RESPONSE TO SUBMISSIONS

2016SYE110-WILLOUGHBY-
PGR 2016 WILLO 002 00
MANDARIN CENTRE - 65
ALBERT AVENUE
CHATSWOOD

Prepared for
**MANDARIN DEVELOPMENTS PTY LTD & BLUE
PAPAYA PTY LTD**
15 February
2021

Figure 1 Development Concept History

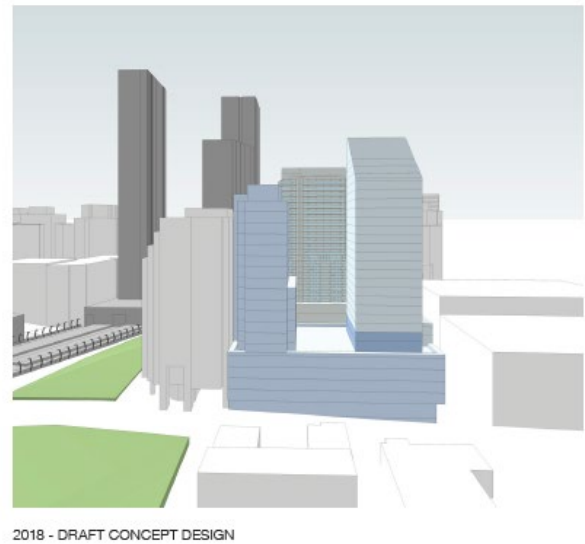
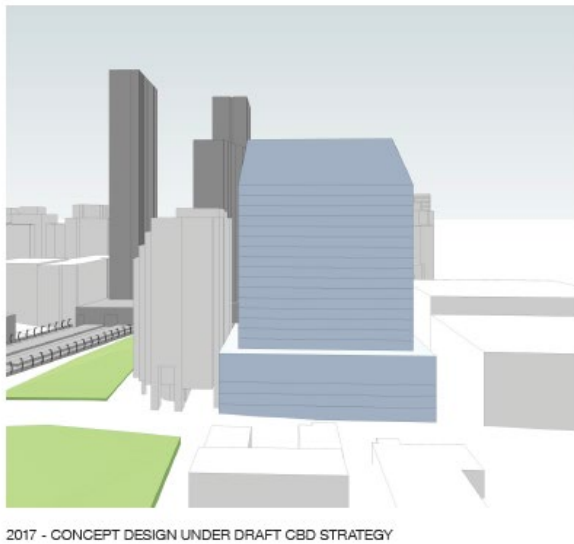
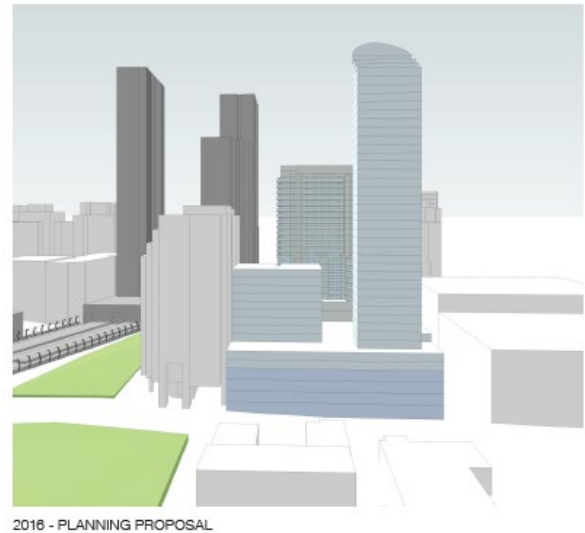
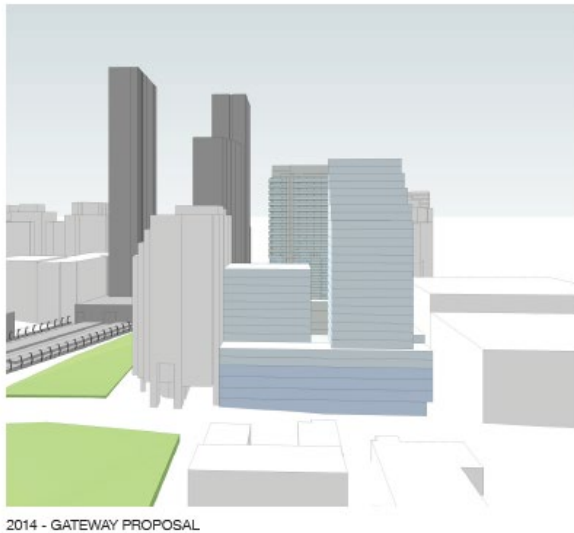
- Loss of views to the Sebel which overlooks the Mandarin Centre to the north.
- The increase in height and floor space would have an unacceptable impact on neighbouring properties.
- The actual visual impacts associated with the potential development of the site are far reaching and not accurately represented in the visual impact analysis.
- Tenacity principle - underscores why the Planning Proposal should be rejected as good planning would avoid the need to resort to such principles.
- View loss is not consistent with CBD Strategy considering site constraints and surrounding context.

- The proposed building separation opens additional views from the single aspect apartments at the lower level of the 'Sebel' that were previously impacted by the 2015 and 2016 Planning Proposals (Figure 1) which also illustrates the significant impact of an envelope that is consistent with the CBD Strategy (bottom left).

Figure 2 Separation Distances (Original PP vs Gateway Design)

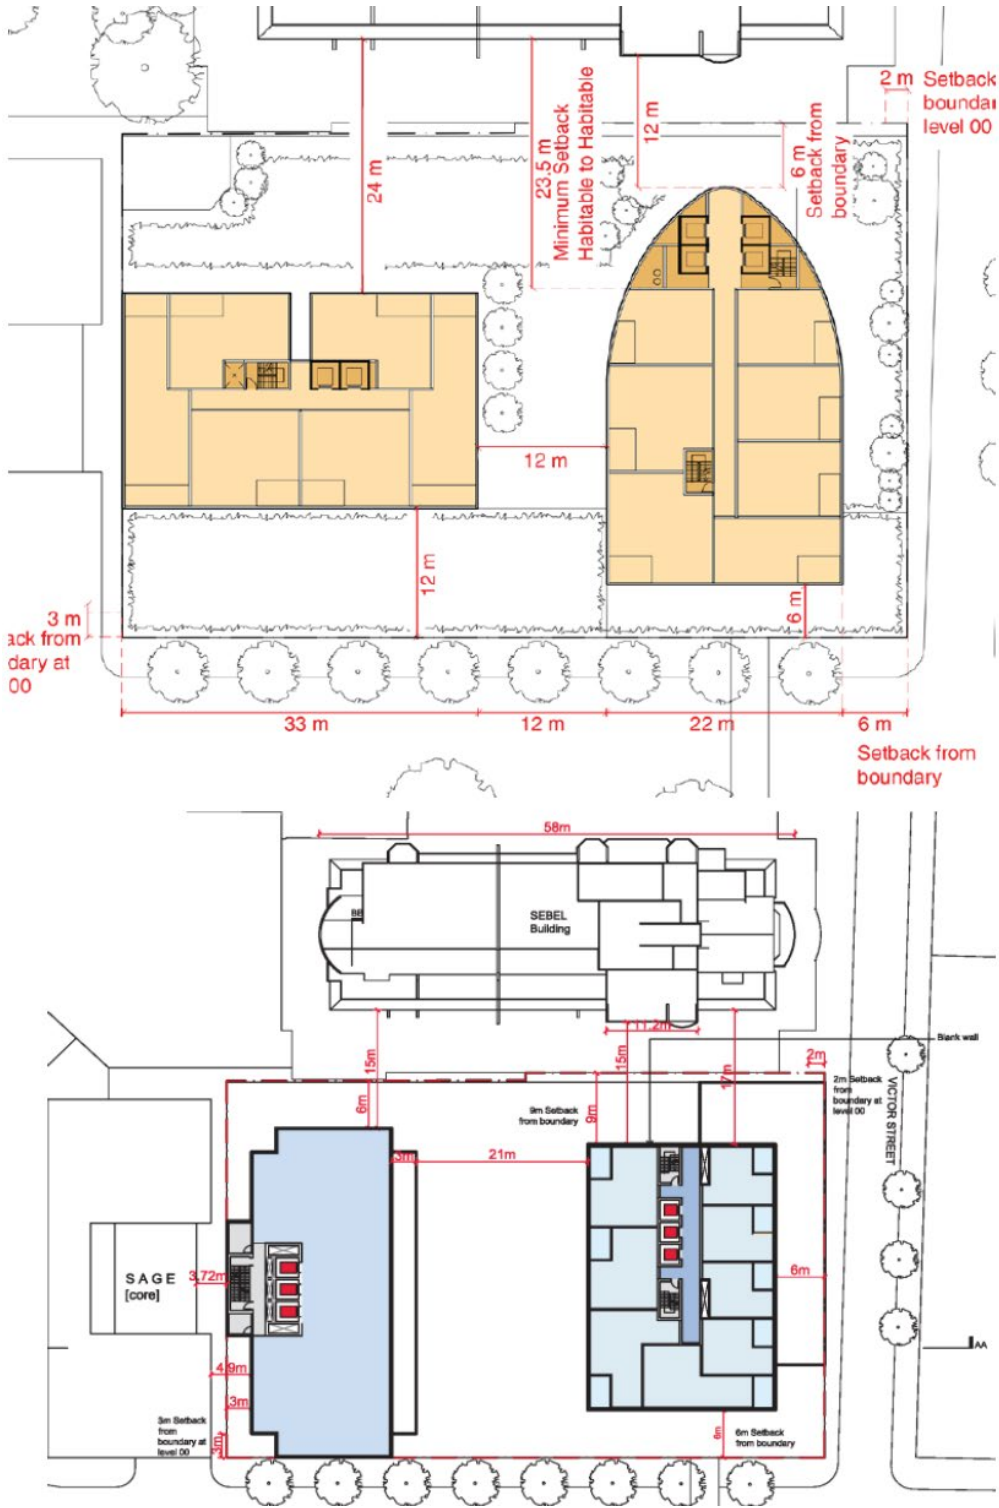
- Windows will look directly opposite and into the Sebel. This will result in curtains having to be continually closed.
- The concept scheme does not comply with the recommended building separation.
- A building separation to the Sebel residential building of 15-17m. The Planning Proposal report states an 18m separation distance is required to The Sebel building for compliance with Objective 2F (Building separation).

As shown in Figure 2 the current Planning Proposal has increased the separation to Sebel from 12m to 15/17m and separation between the towers from 12m to 21/24m. The following responses are also made in relation to separation distances:

Figure 4 Proposed concept design setbacks and building separation

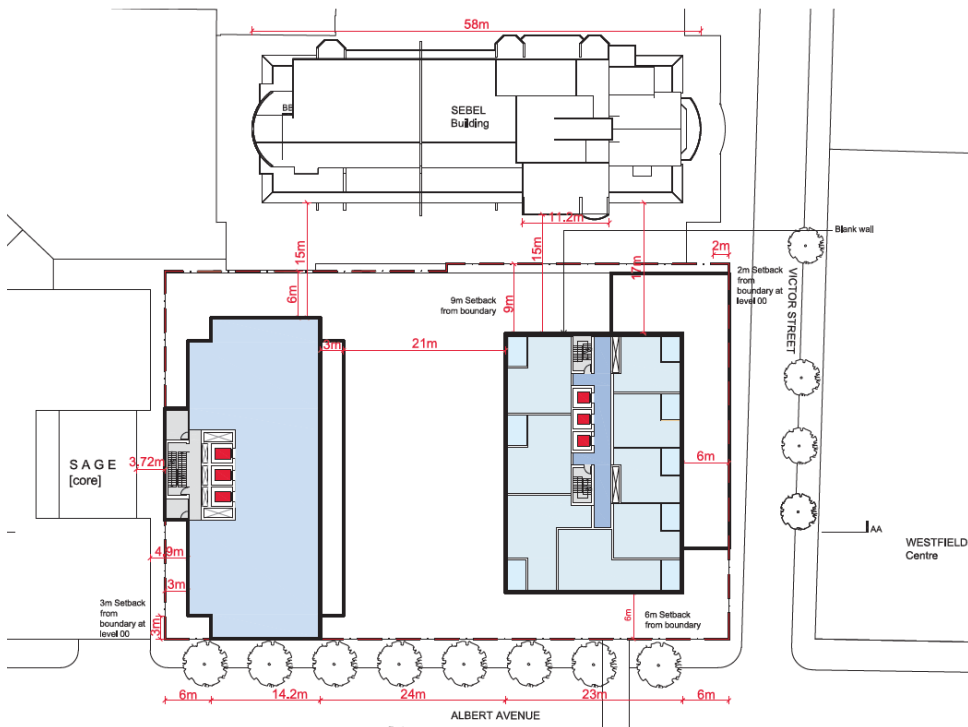
- *The Key Element is a standard requirement for Planning Proposals seeking to utilise the Strategy and would apply to the subject site. The FSR of 11.11:1 does not satisfy Key Elements 13 c) and d) above, and should be revised accordingly to be consistent with the envisioned outcome. This will have an impact on FSR.*

Two slender towers have been provided above an upgraded shopping centre. As illustrated in Figure 4, the proposed 21m to 24m separation between the residential and commercial towers on the site is generally consistent with the ADG. As previously mentioned, the separation is also significantly greater than the minimums required for commercial and residential towers in comparable high-density environments. For example, in Sydney CBD a building greater than 45m in height, requires a 15m separation when provided on the same site.

Picture 3 Recommended sun access protection for public spaces (excerpt from CBD Strategy)

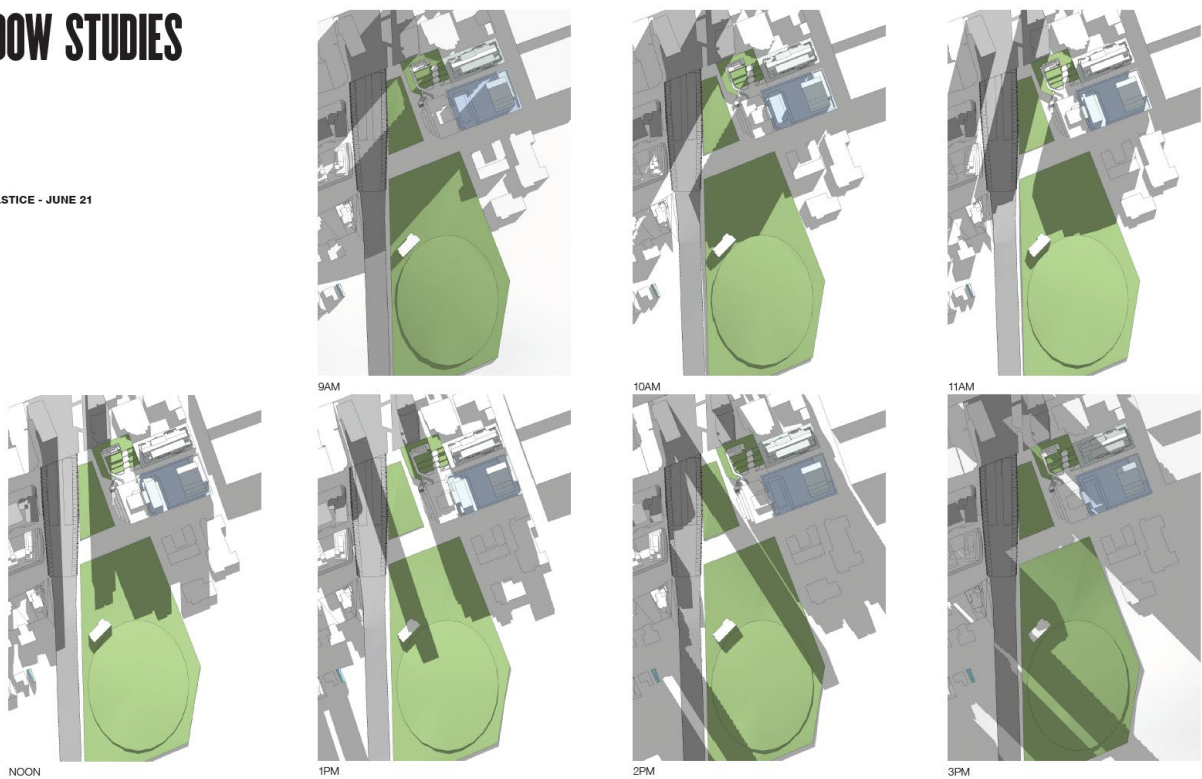
However, the shadow diagrams provided (Appendix 1) do not clearly show the overshadowing directly related to the subject concept plans development, with all overshadowing shown in the same colour. Shadow diagrams are requested that clearly show:

- Overshadowing for what is proposed, together with any other overshadowing from other development. For clarity purposes, if the overshadowing is within existing shadowing, this still should be highlighted on the plans. Any additional overshadowing should also be shown.
- Pre and post development shadow diagrams for a comparison. The above information is to clearly indicate the impact of overshadowing from the subject Planning Proposal on the three key public spaces abovementioned, with particular regard to Chatswood Oval (and Chatswood Park).

Overshadowing has been extensively examined throughout the various versions and stages of the Planning Proposal, this included certified shadow diagrams (submitted with original PGR scheme). It is our opinion that the shadow diagrams provided are appropriate for this stage of the planning process (refer Figure 5).

Figure 6 Section Plans demonstrating proposed concept design height

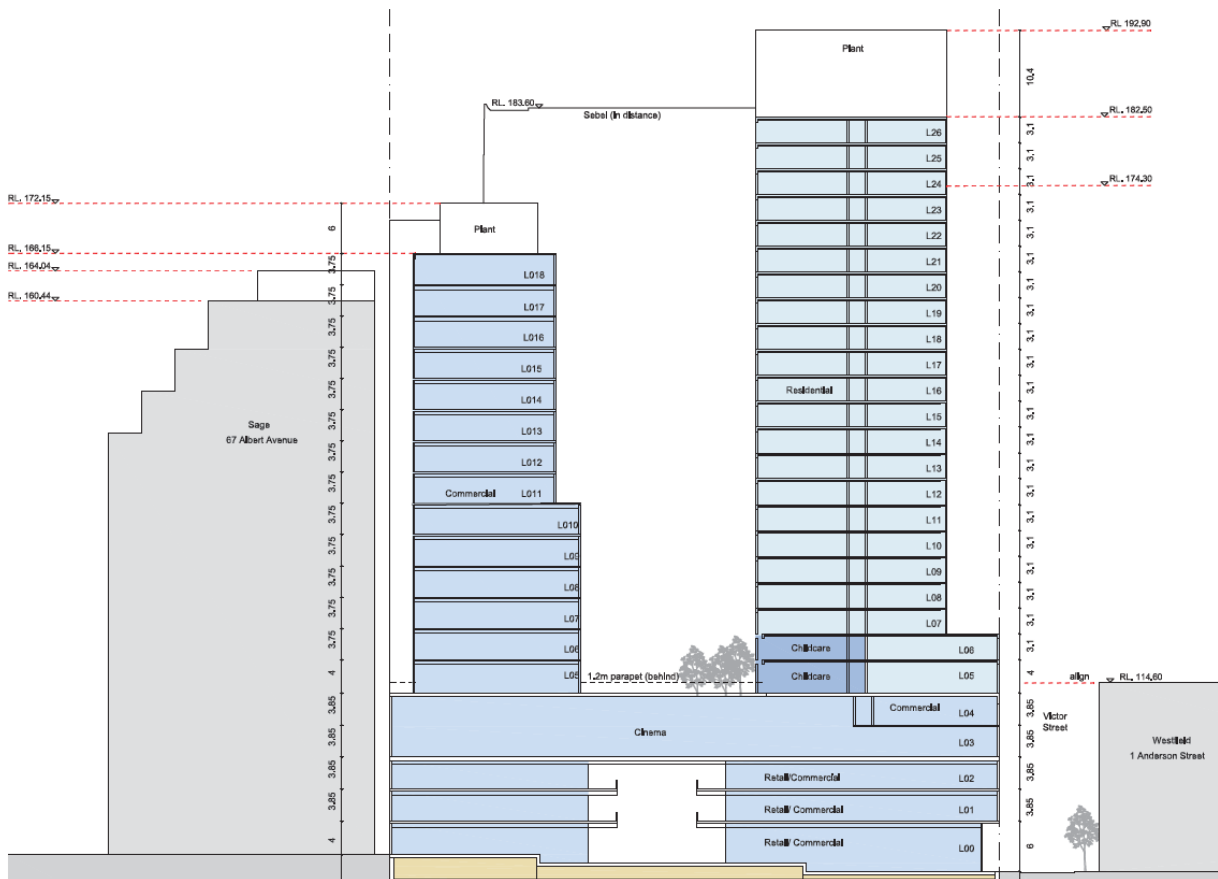
Requested that elevation and section plans refer to RL heights, metres and storeys.

The section plans provide a detailed breakdown of height in RL, metres (floor to floor) and storeys. An excerpt of Section AA is provided in Figure 6 below. Detailed elevation plans showing the overall height in metres can be provided if required by DPIE and the Panel.

Figure 7 Through site linkages consistency with CBD Strategy

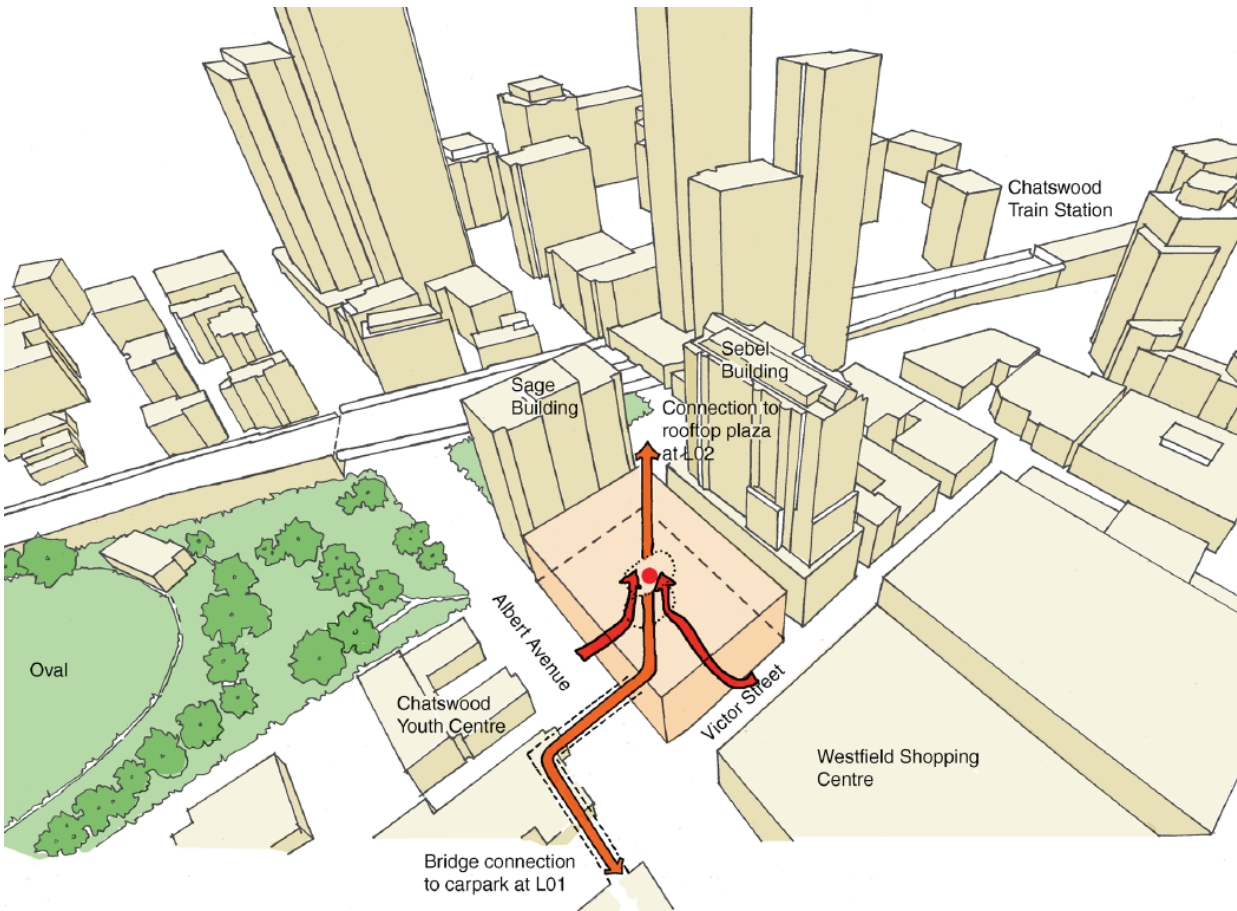
Analysis is required to clearly identify how the requirements in Figure 3.1.7 (page 36) of the strategy have been addressed. How is this space to be managed and public access guaranteed?

These proposed linkages are provided from both Albert Avenue and Victor Street as demonstrated in Figure 7 below. These enlarged circulation areas will also improve access to Chatswood Station and areas west of the rail line.
